Brewery Road Apartments, Stillorgan, Co.
Dublin

Stormwater Audit Stage 1

Document Number: 192-206-SWA-S1

DRAWN G.Byrne	DESIGNED EC	APPROVED JG	DATE APRIL '19
SCALE 1:500 @A3	JOB NO. 18-093	DRG. NO. P208	REVISION

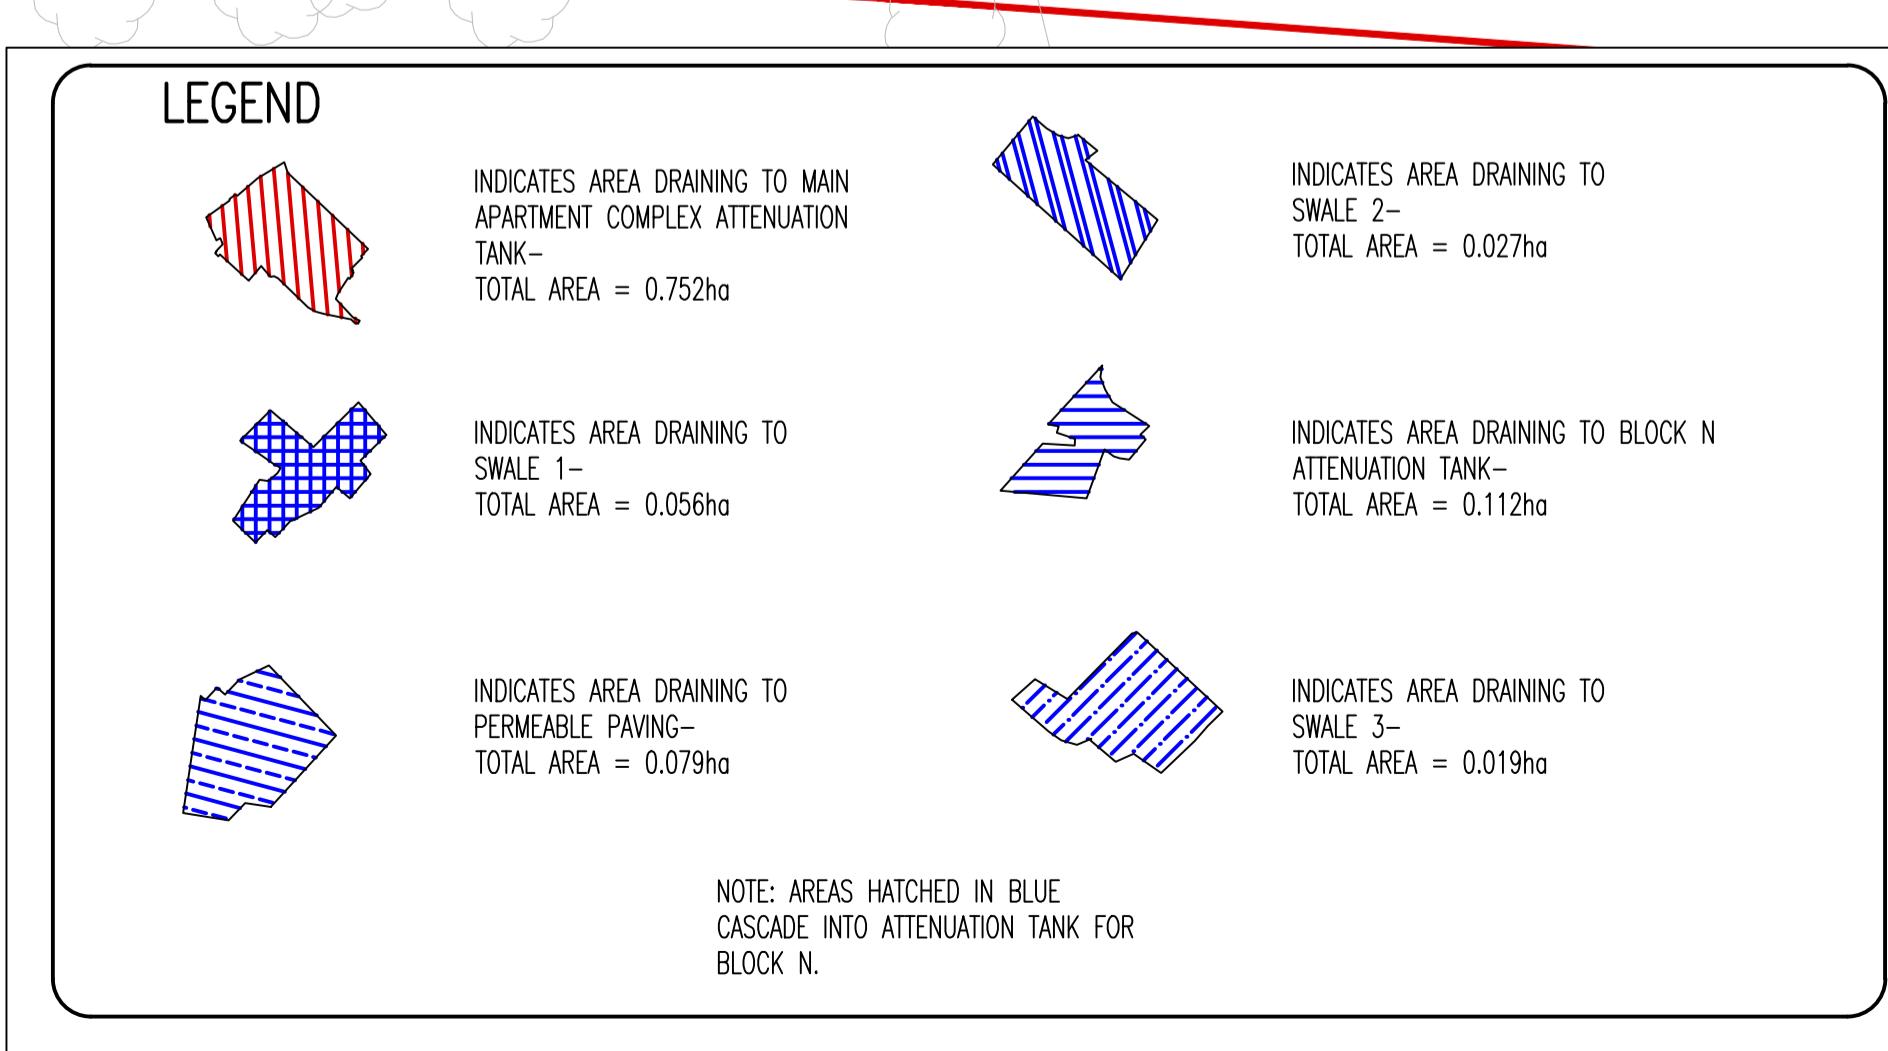
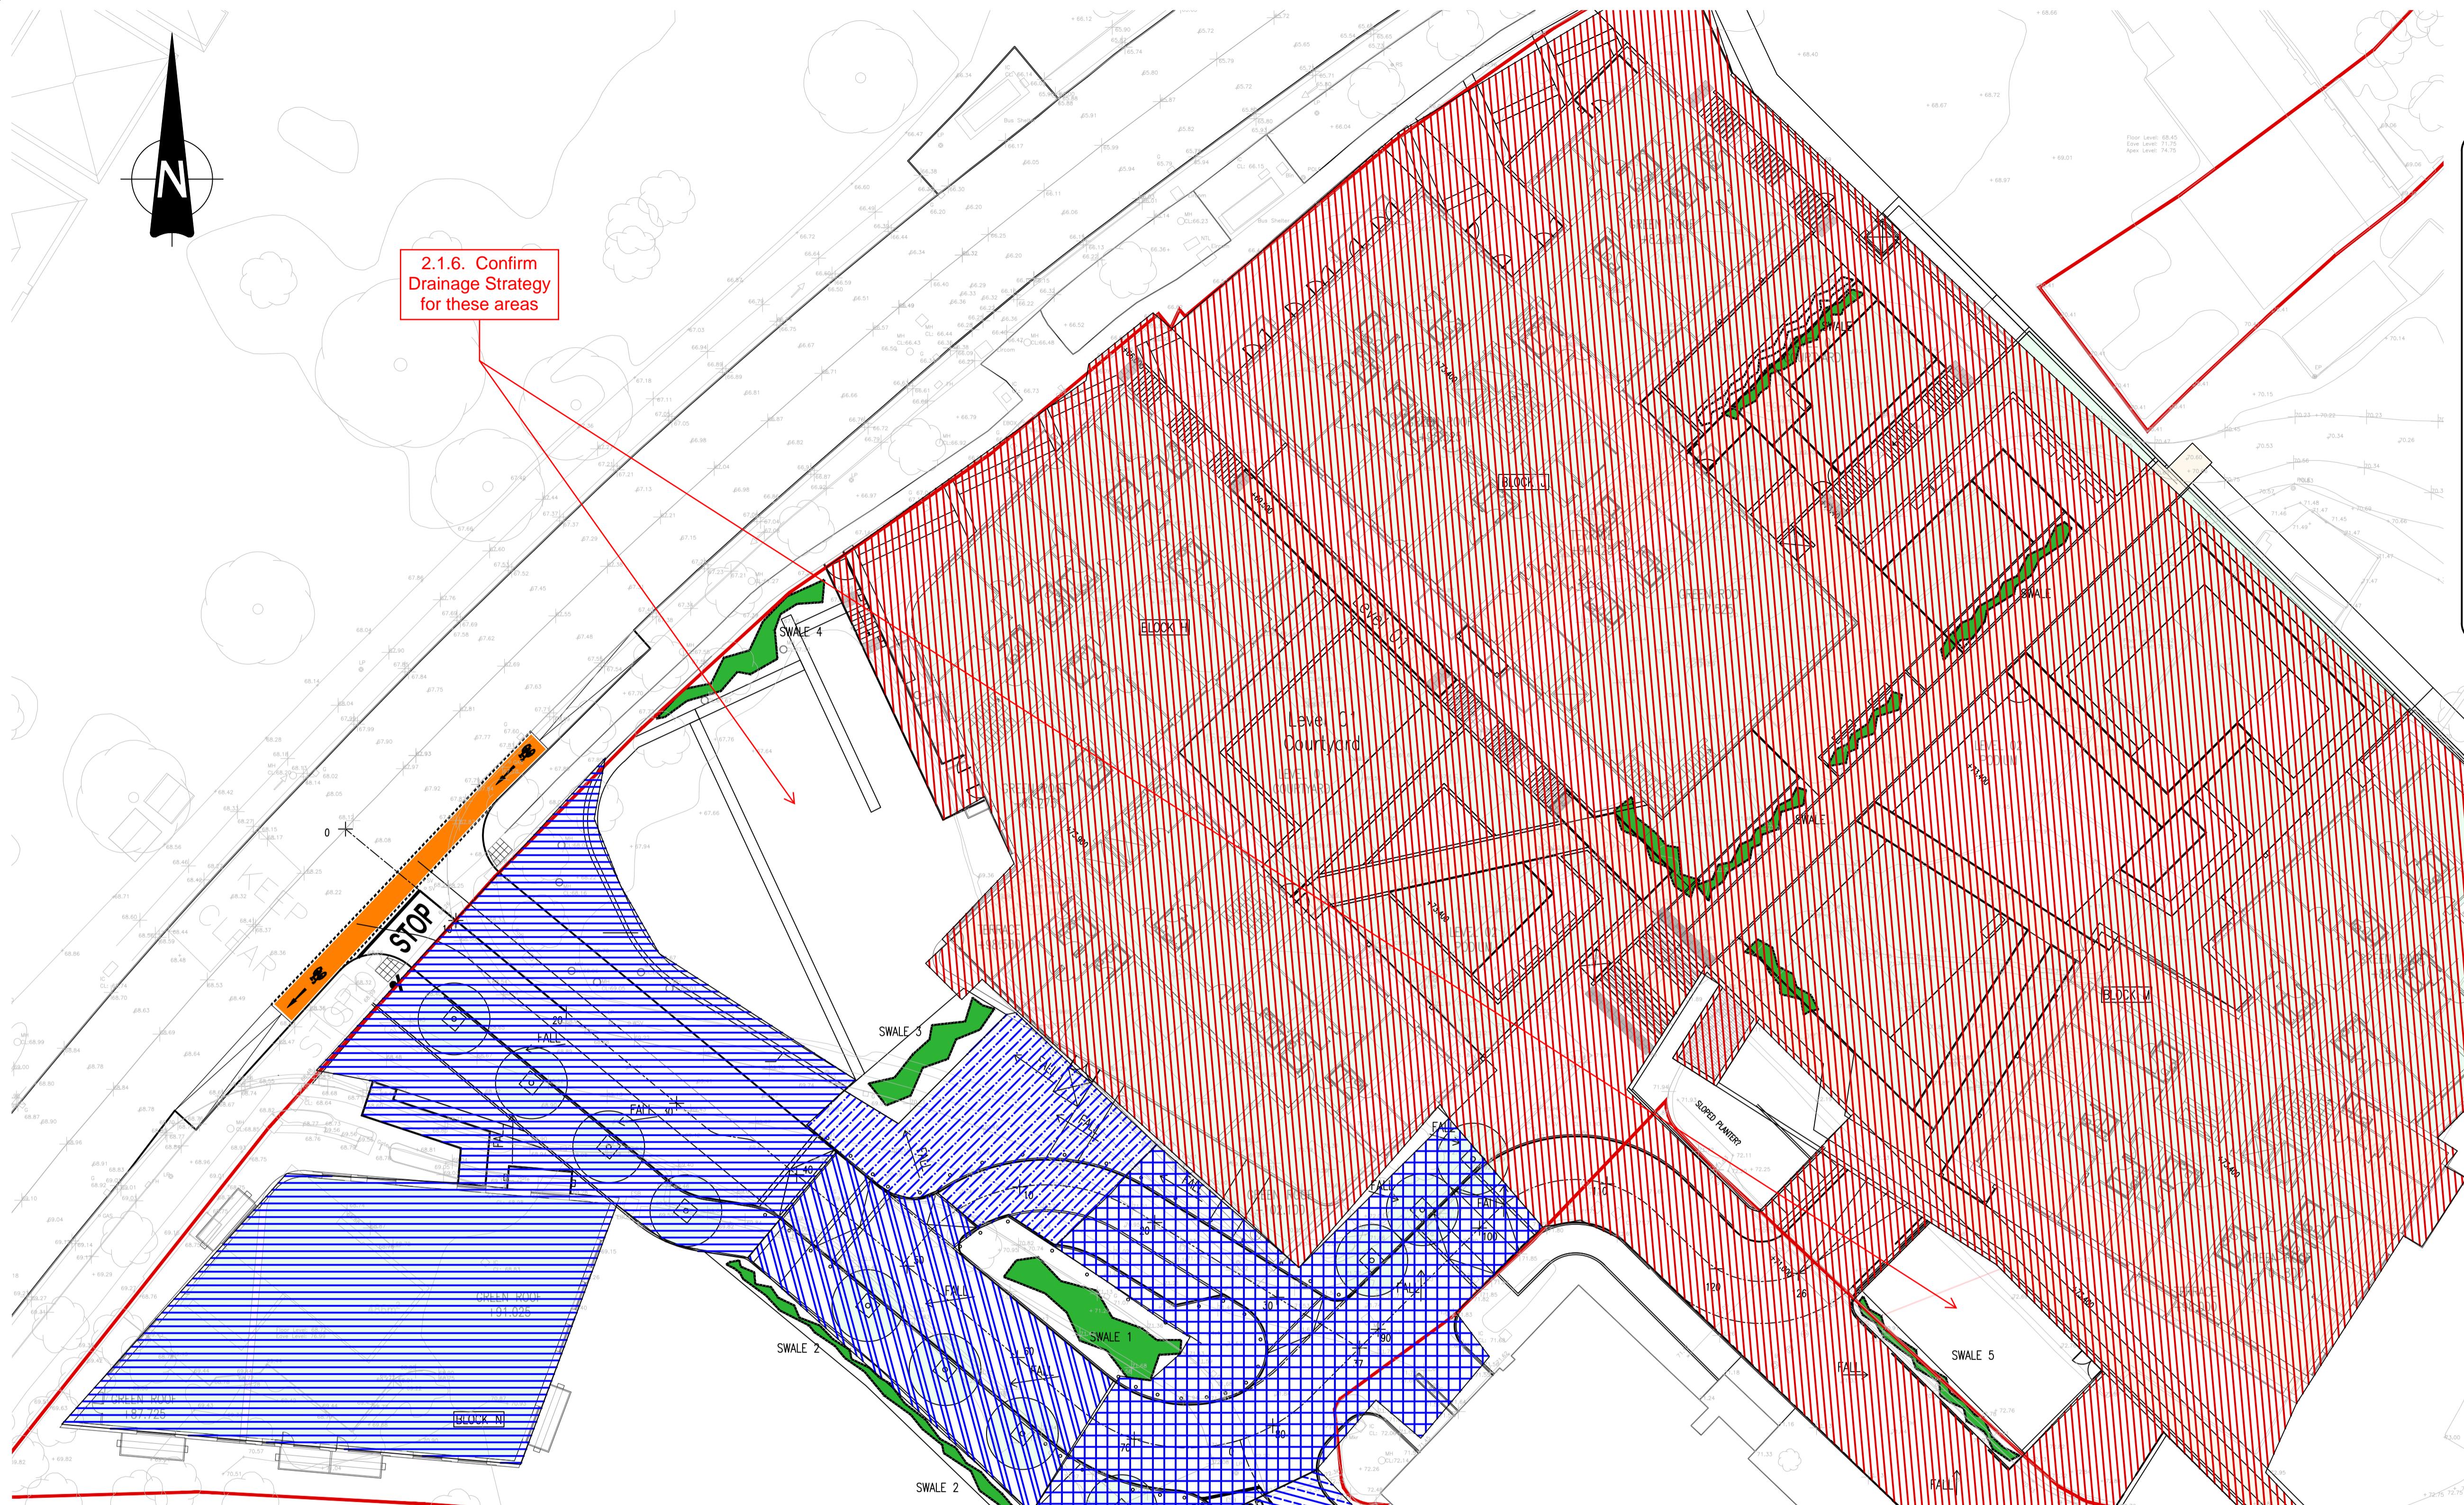
Problem: SUDS attenuation Strategy drawing has several areas where it is not shown where they drain to.

Recommendation: Confirm whether these areas are to be attenuated and if so where.

2.1.6	Y	Y	See revised drawing P208 attached. The areas that have not been hatched are planting/green areas which do not require positive draige.	Yes

PLAN VIEW - ATTENUATION TANK 1 AT LEVEL 01

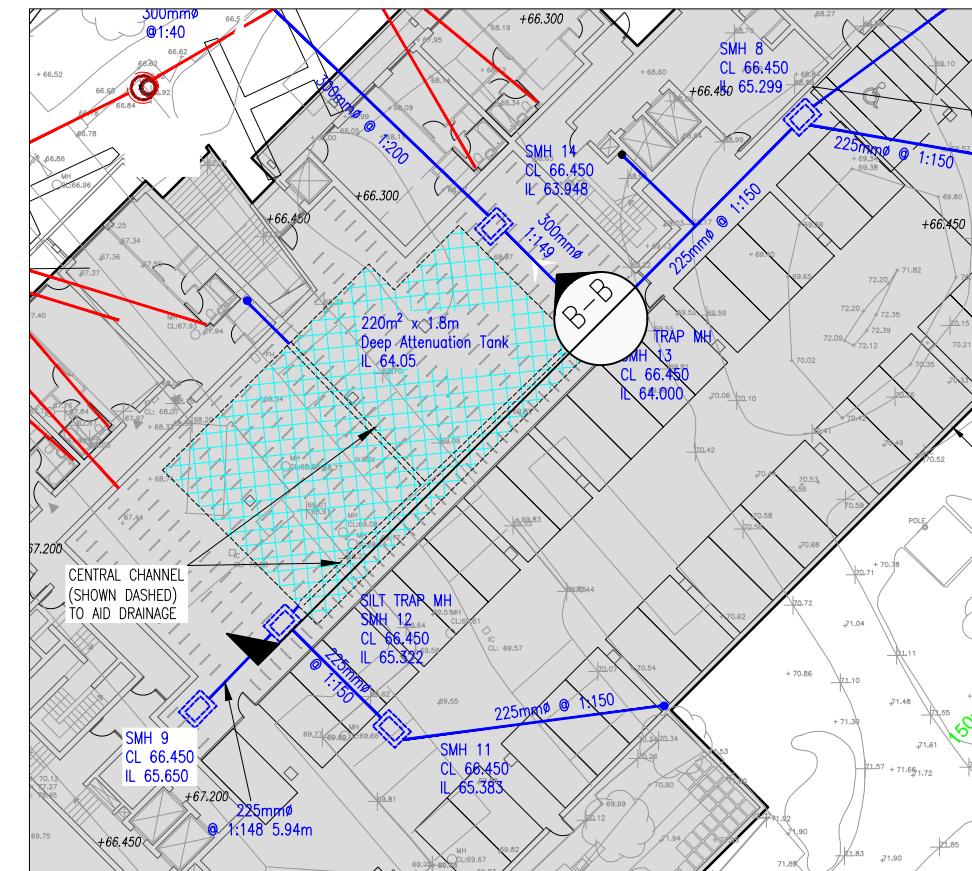
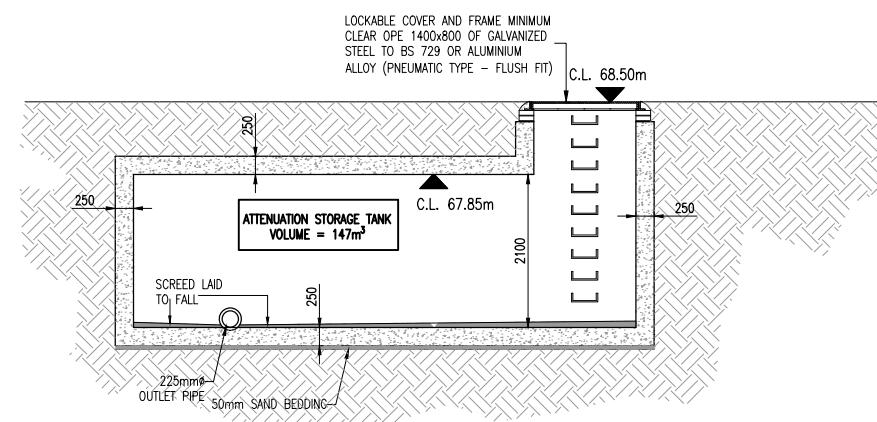
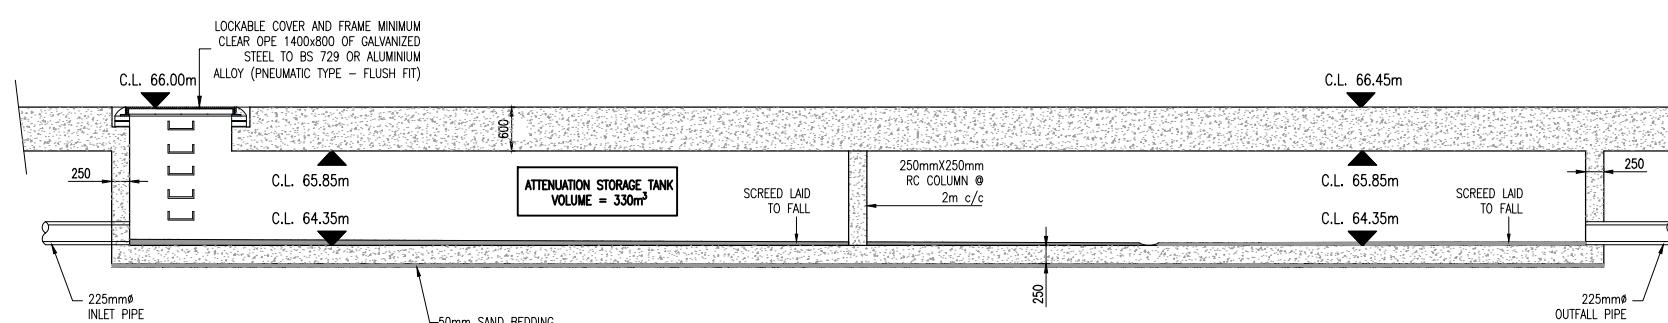
Problem: details of attenuation tank outside Block N not submitted.

2.1.13	Y	Y	See details of tank outside Block N attached on drawing P211.	Yes
2.1.14	Y	Y	Access can be provided from the cycle parking area for general maintenance. If a large vehicle is required for pumping it can park on Brewery Road and provide a rising main through the ground floor access to the cycle store from Brewery Road.	Yes

DRAWN G.Byrne	DESIGNED EC	APPROVED JG	DATE APRIL '19
1:250 0A1	JOB NO. 18-093	DRG. NO. P202	REVISION

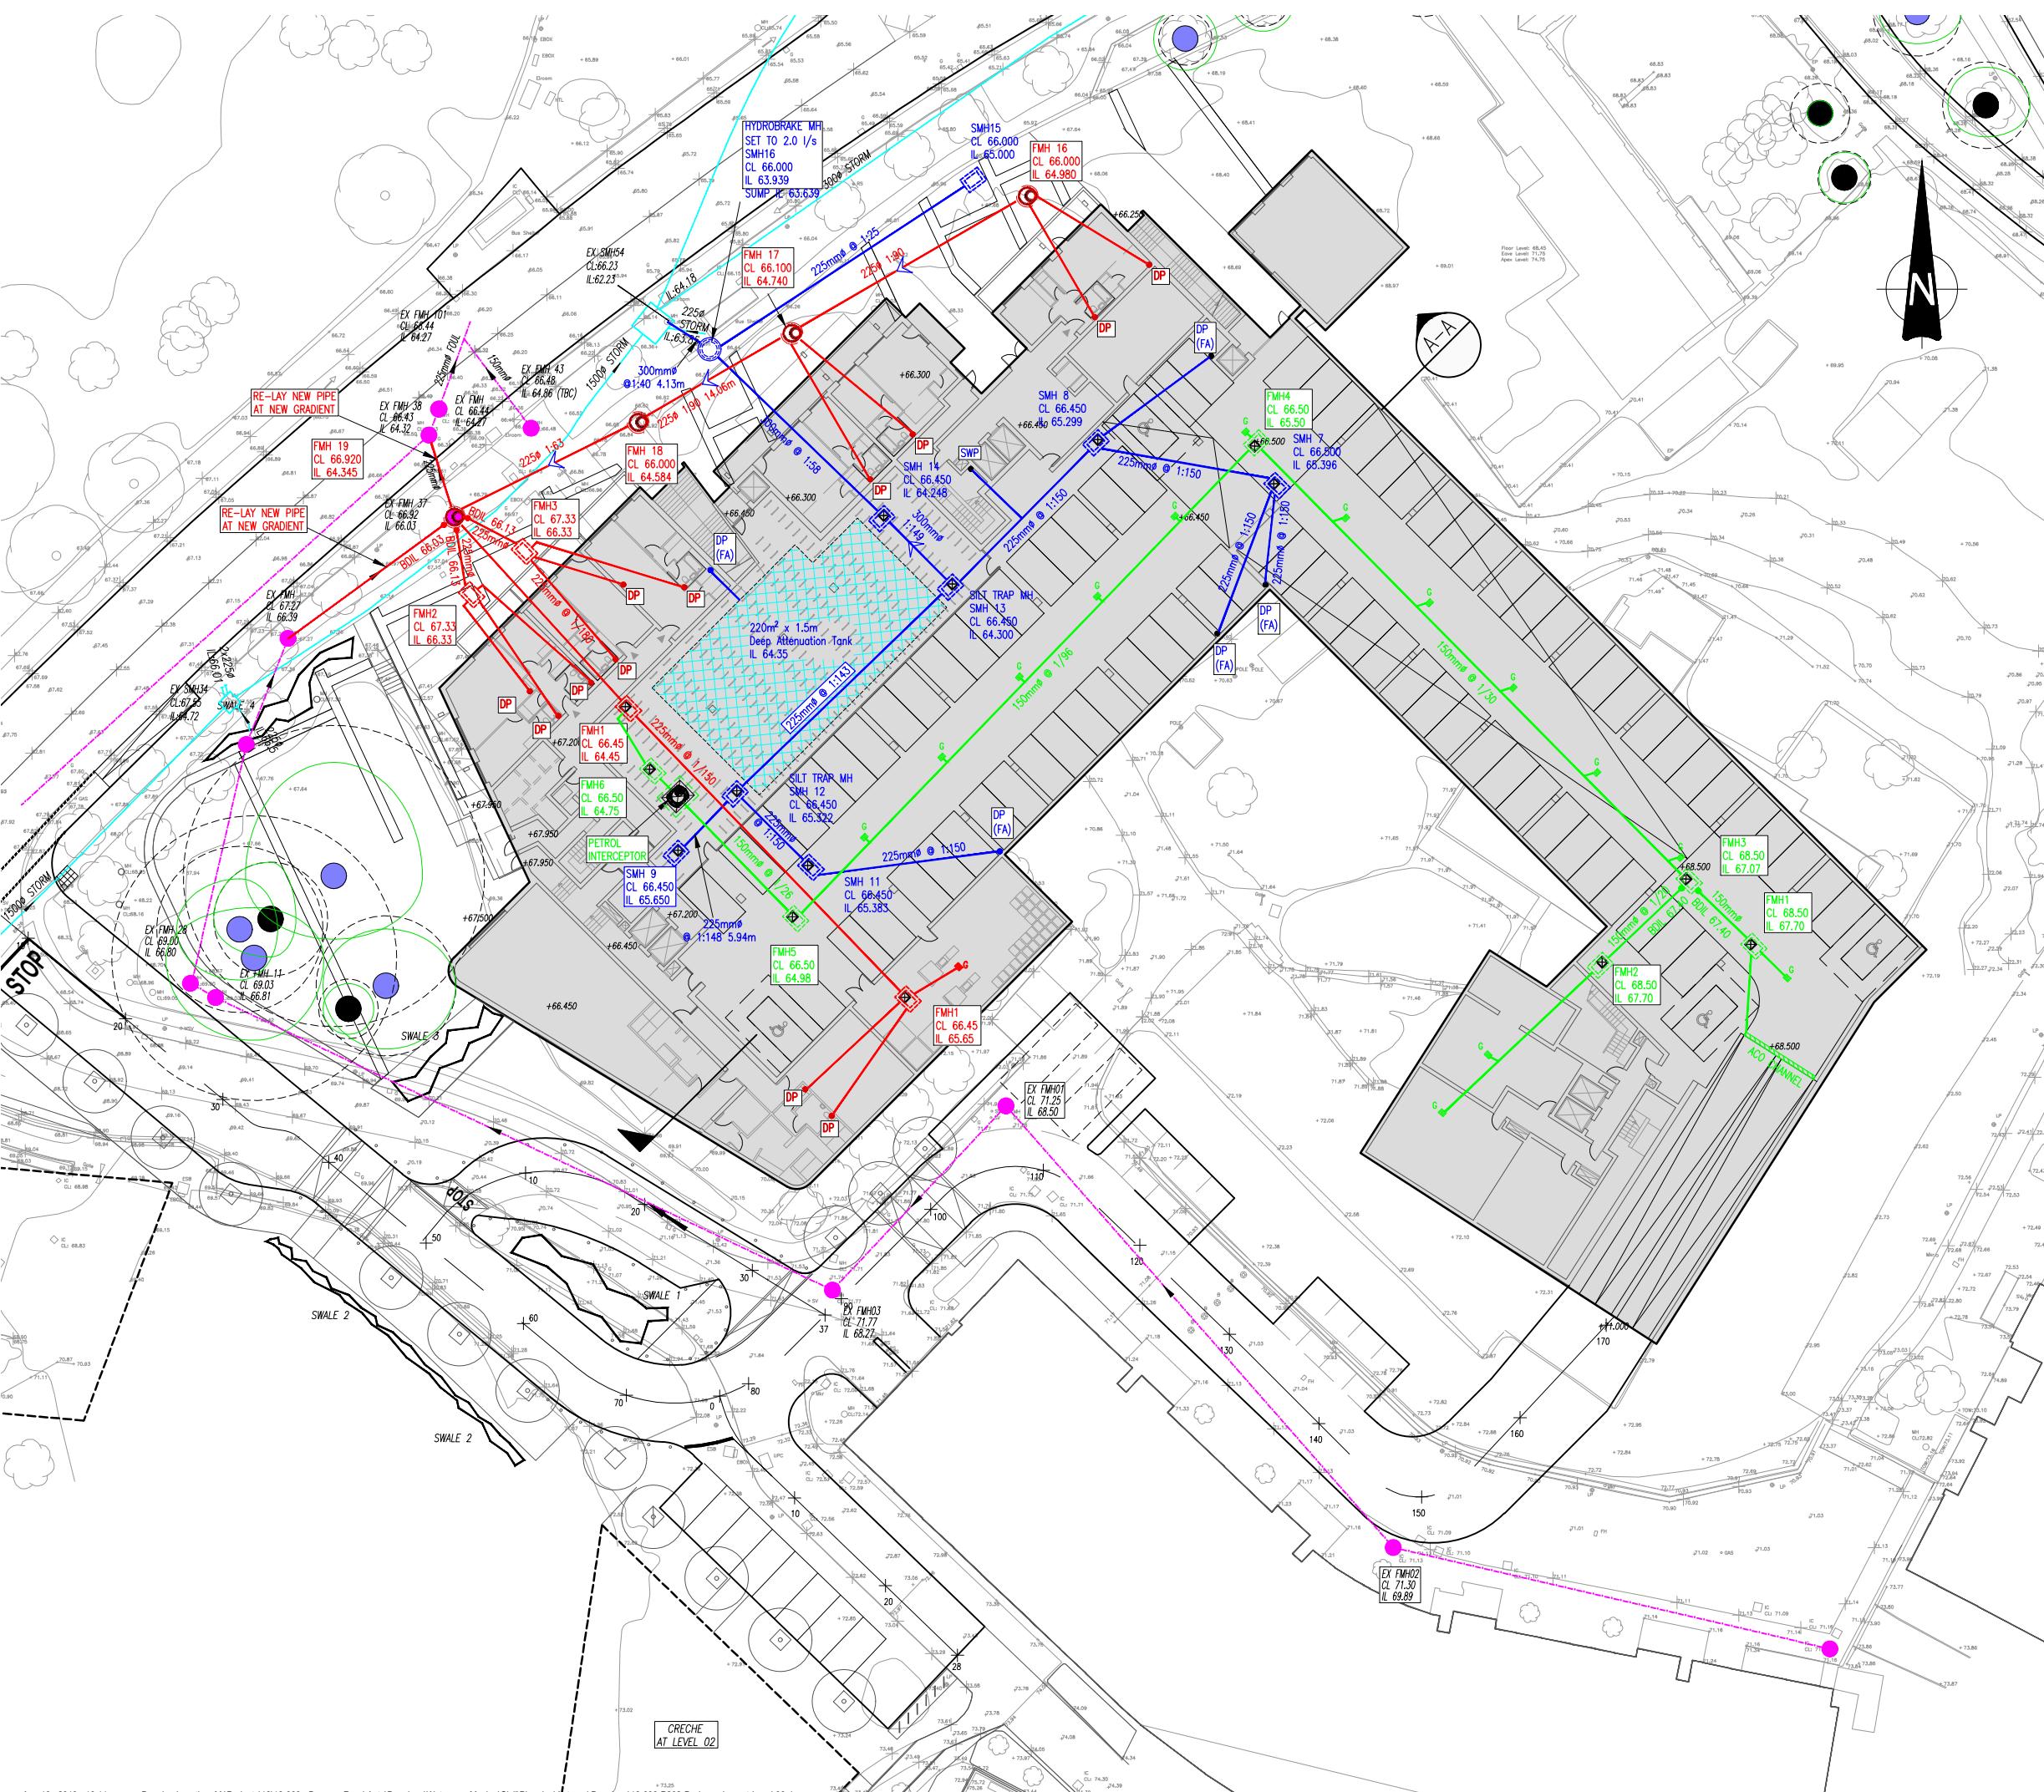
Problem: Silt entering the system and entering the attenuation tank has the potential to cause blockages.

Recommendation: Consider making SMH12 a silt trap manhole similar to SMH13.

2.1.4	Y	Y	See revised drawing P202 attached. SW12 is also a silt trap manhole.	Yes
2.1.5	Y	Y	ACO channels in question are above the basement level and therefore discharge to the basement attenuation tank via high level basement rainwater pipes. In accordance with the architect's drawings.	Yes
